Regulators

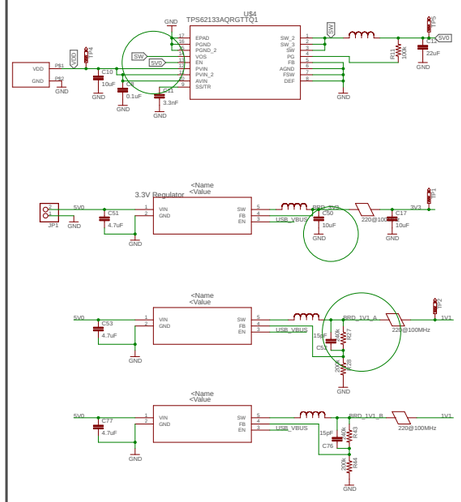
Fix old SPI Flash -- Add AT25DN512C-SSHF-T
Fix 5V reg VOS line (goes after inductor)
Fix enable line for all*
Fix 10uF Cap size after Inductor
Fix reset line to add all GRST including HUB
Fix input power capacitor sizing (6.3V is too small)

1. Change two buck regulators to AP3418KTR-G1DICT-ND
2. Serial Communication for debugging
3. Remove/change JTAG Connectors
